JLG 13070B-5A Construct New IT Center

St Cloud VAHCS Proj. No. 656-14-246

RE: Amendment No. 4

## Amendment No.4 (05.12.2016)

1 PLUMBING BASEMENT PLAN

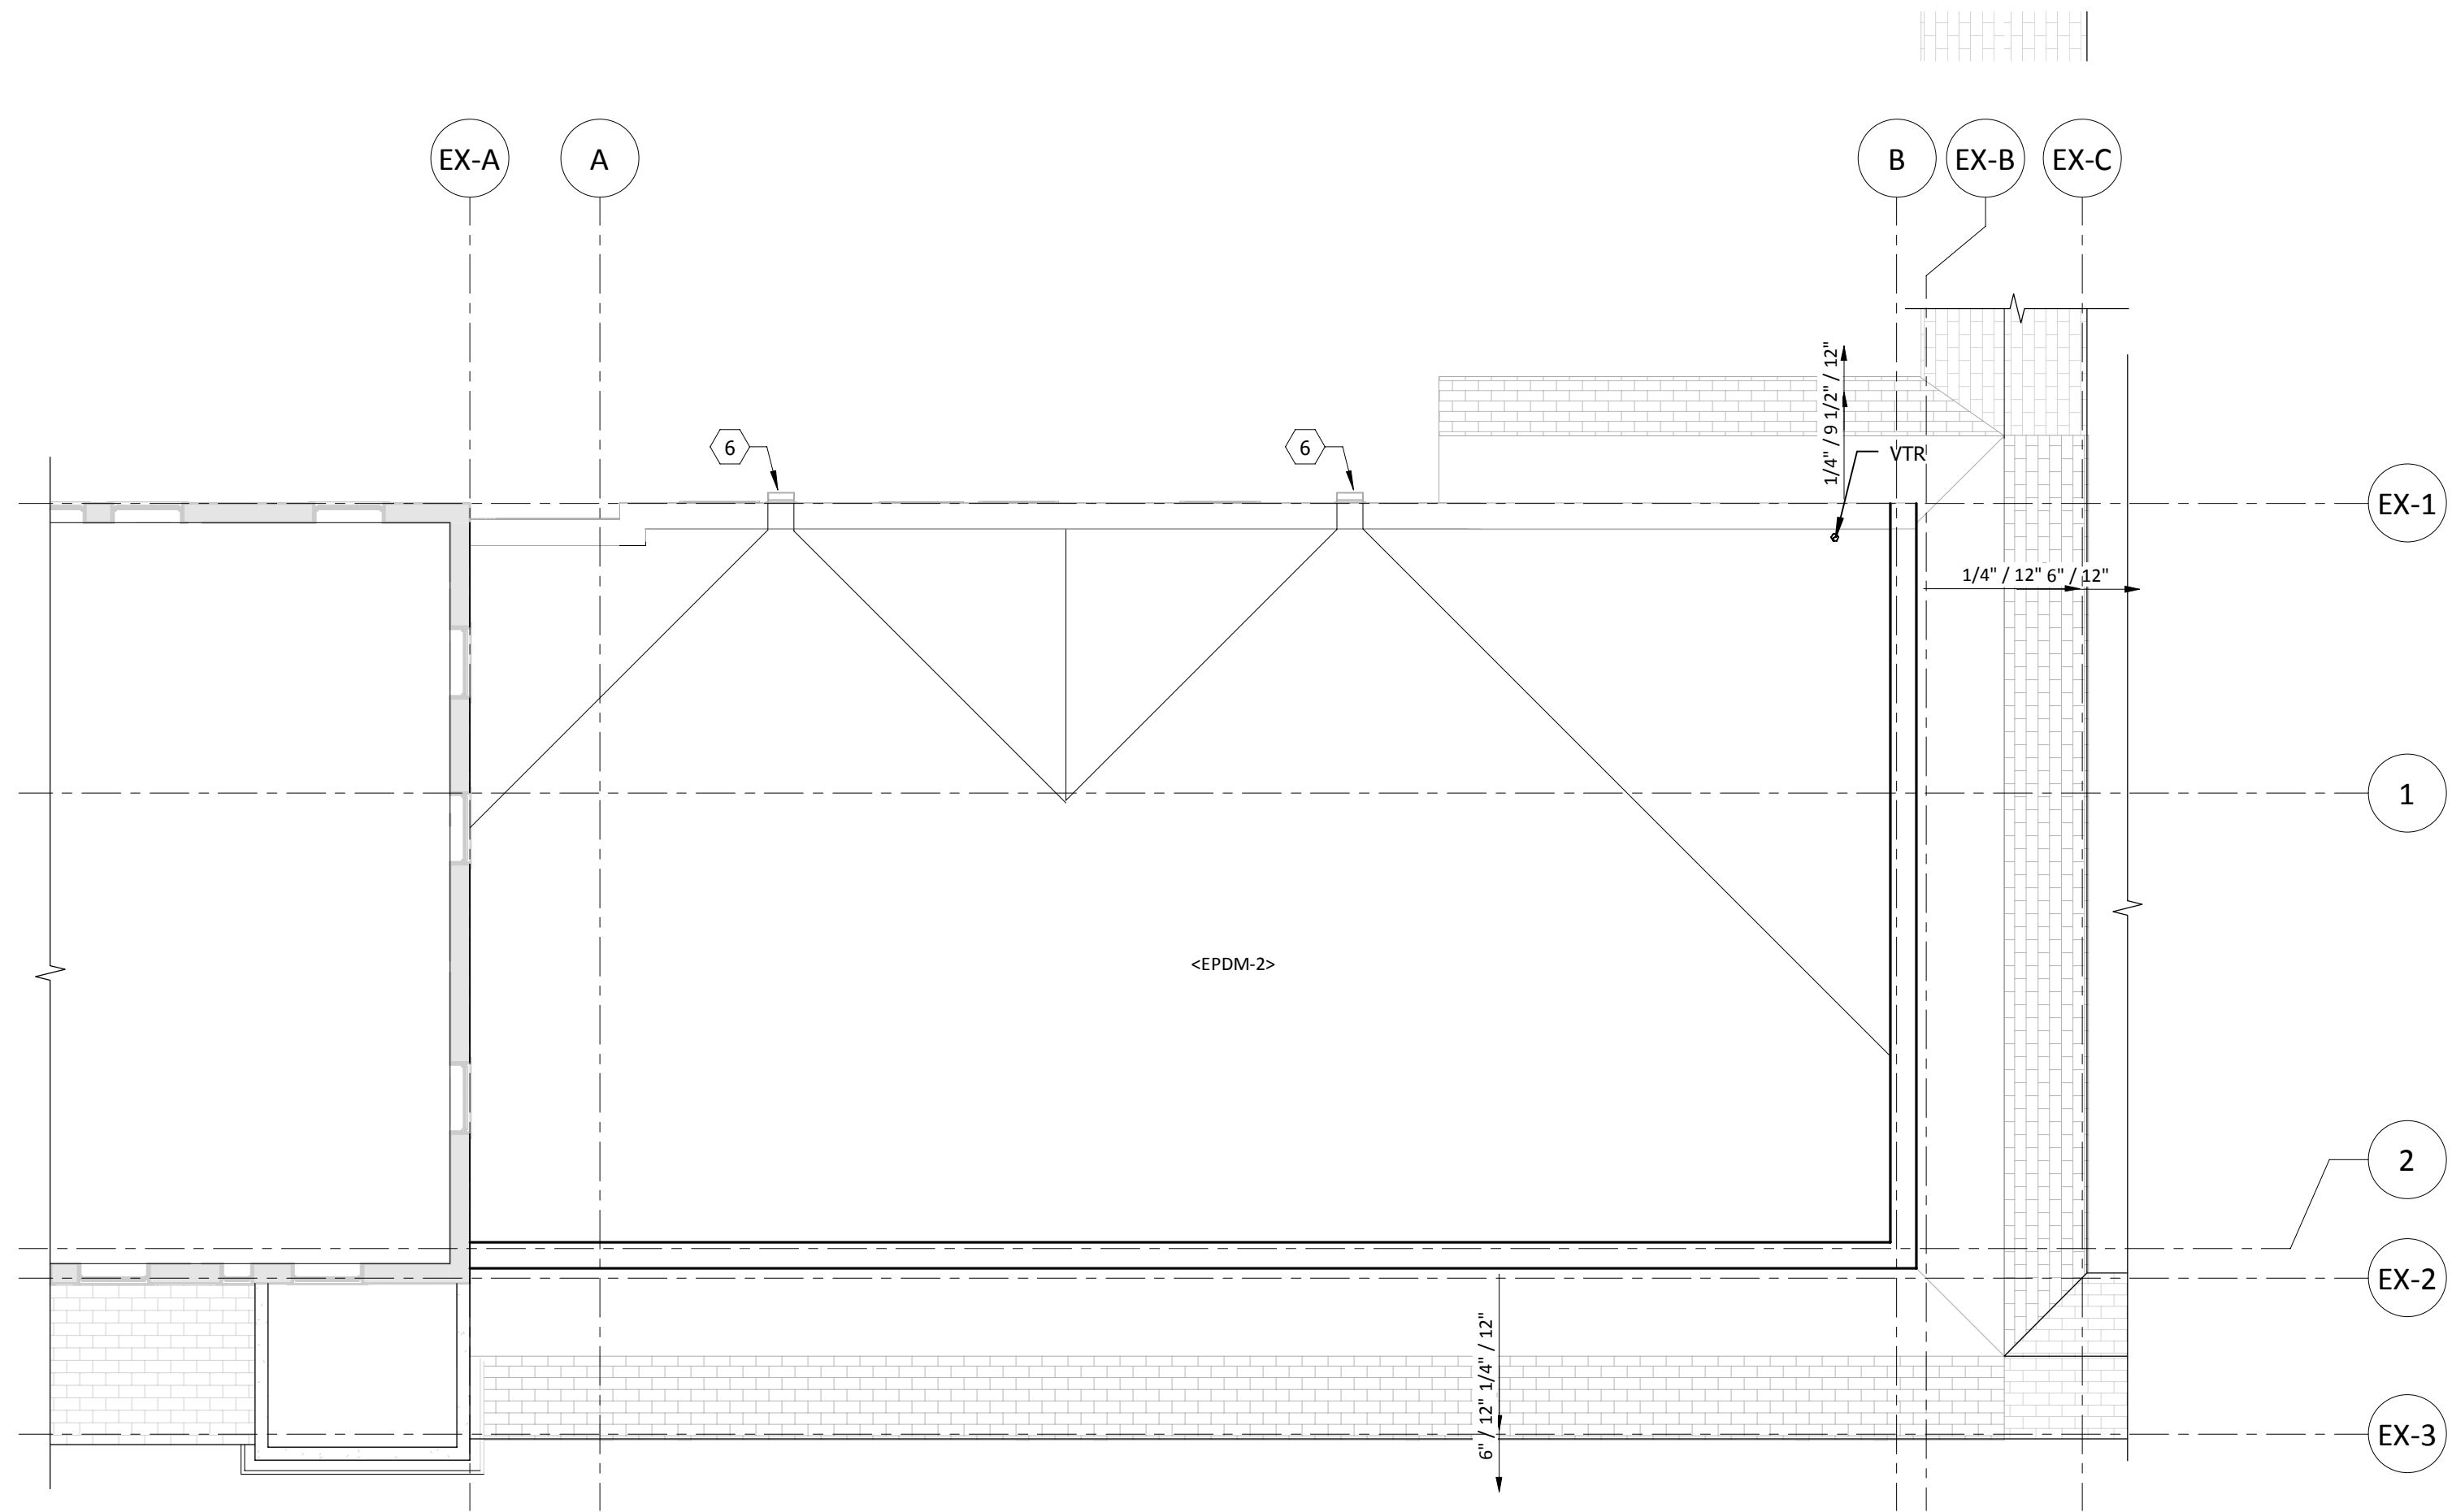
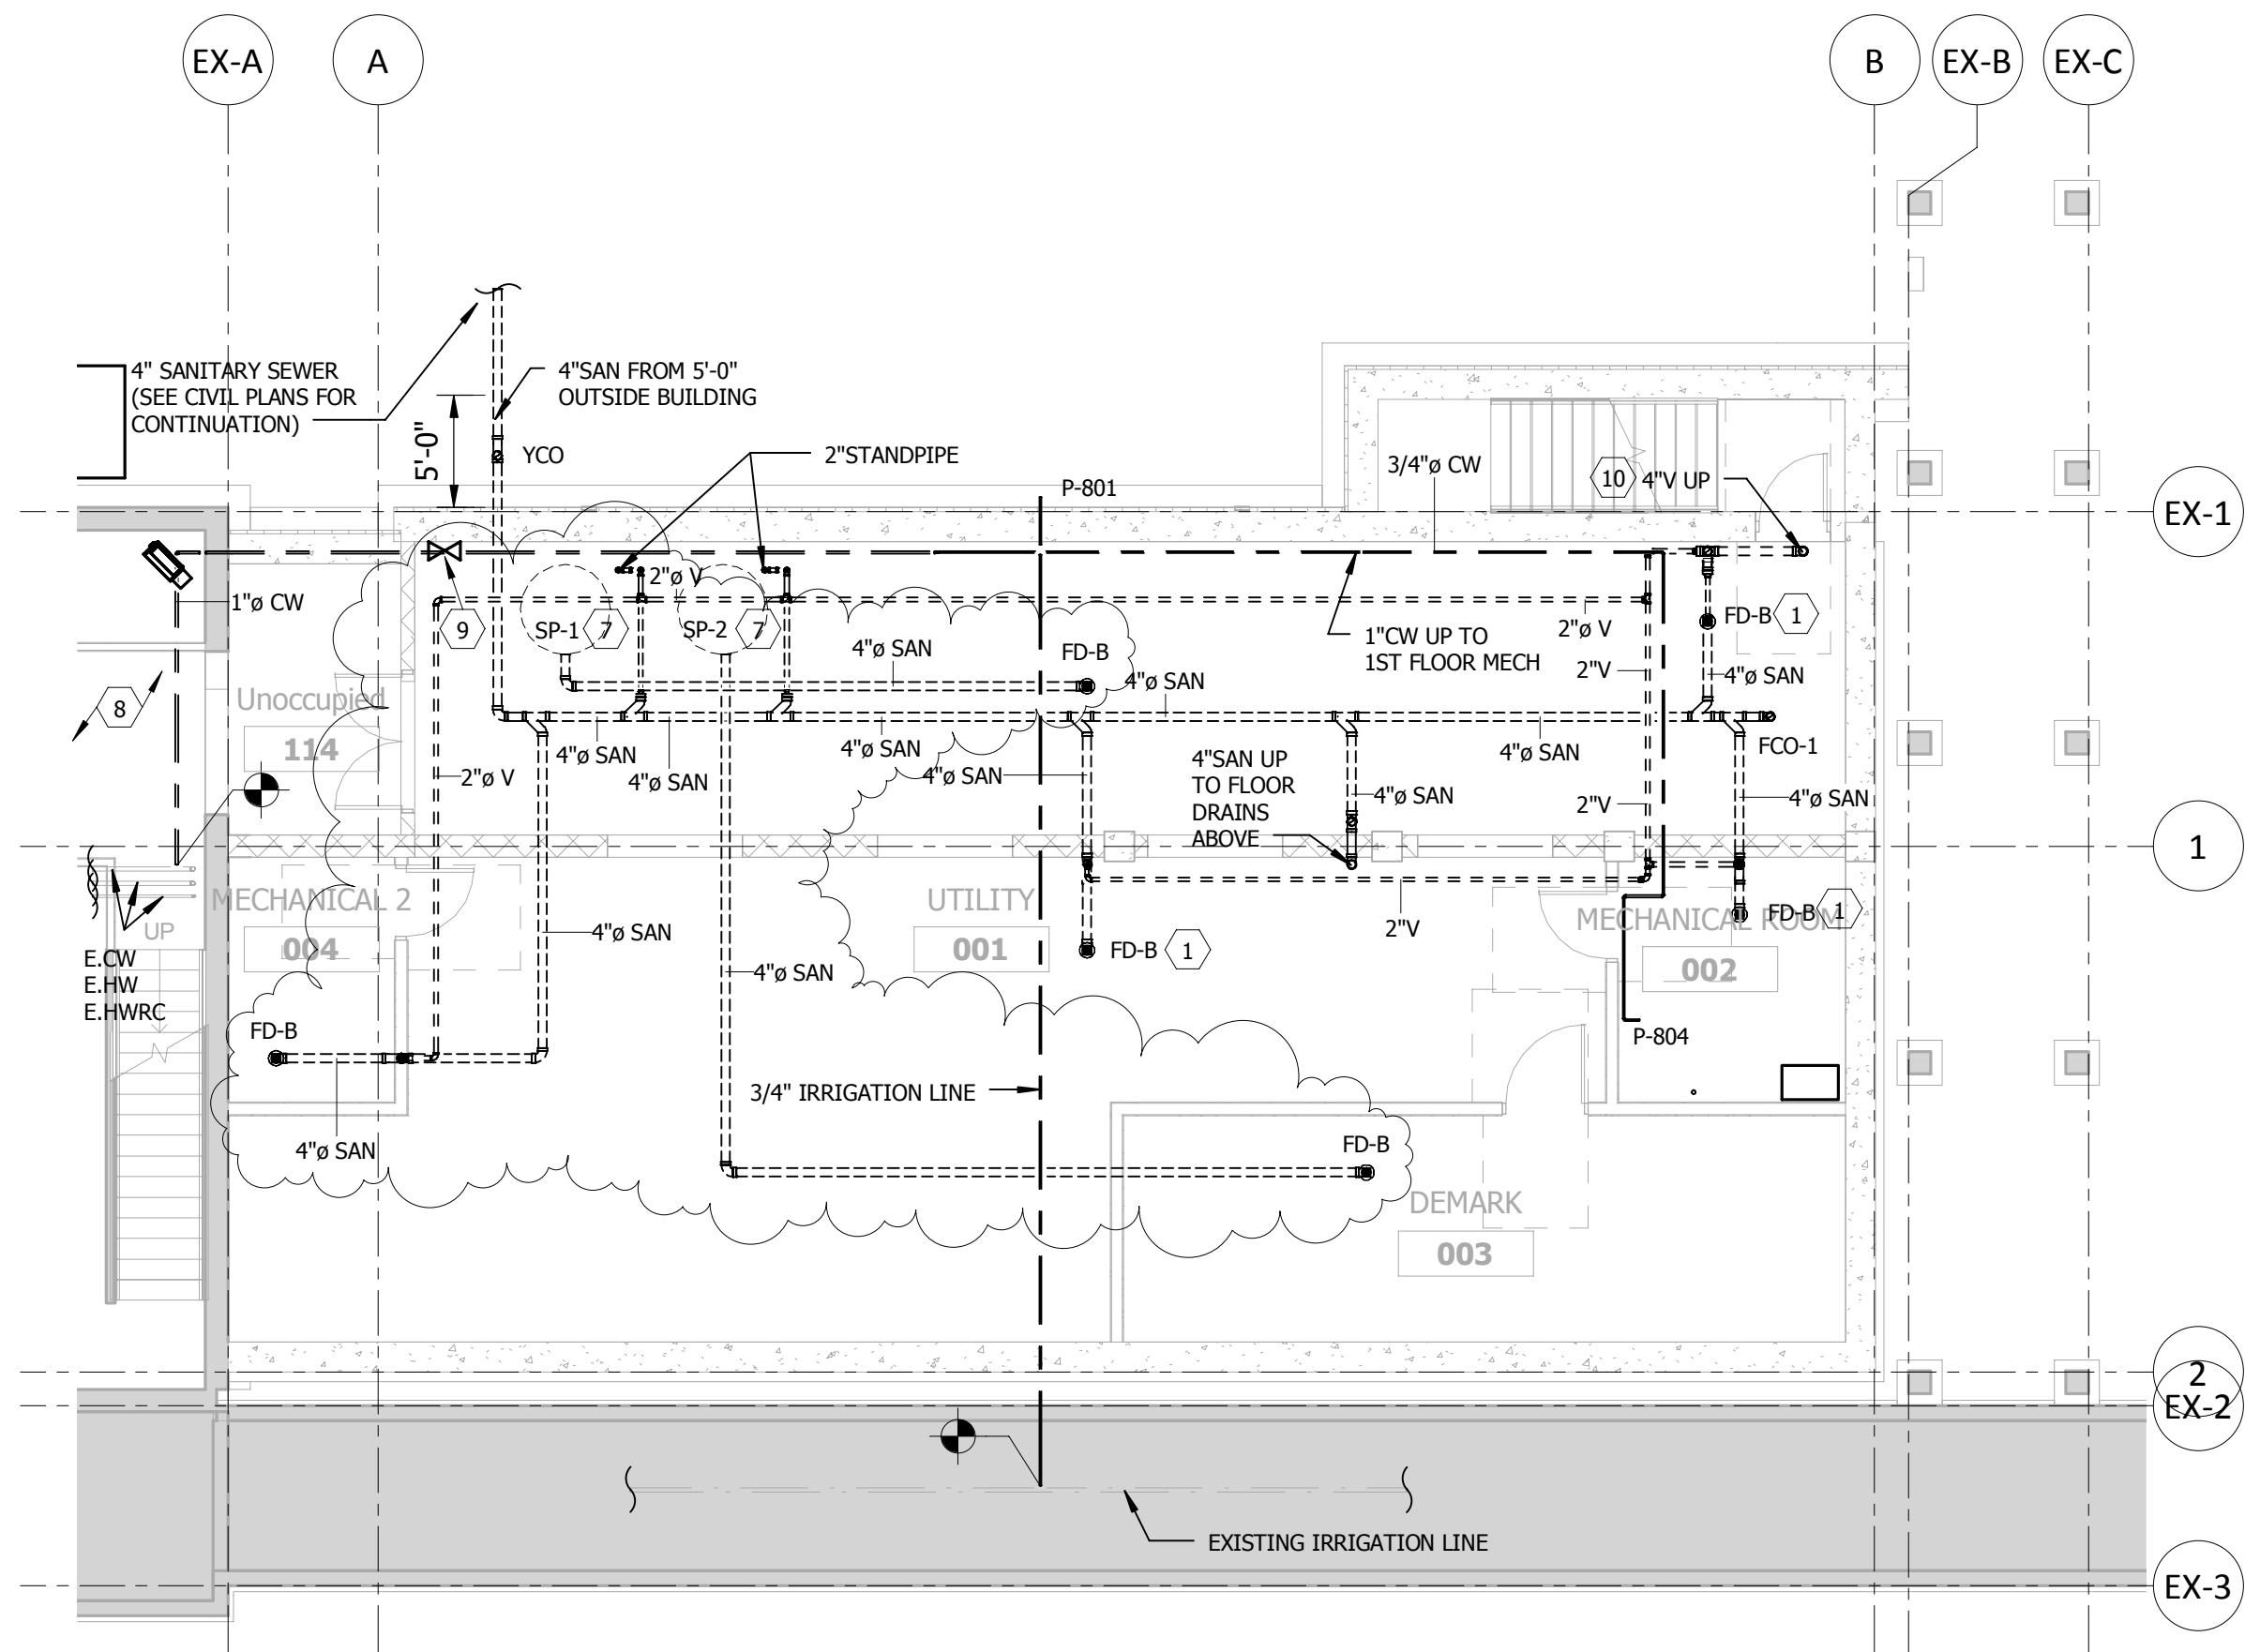
11. Drawing M201, M202, M402, M701, and M801: See attached revisions.
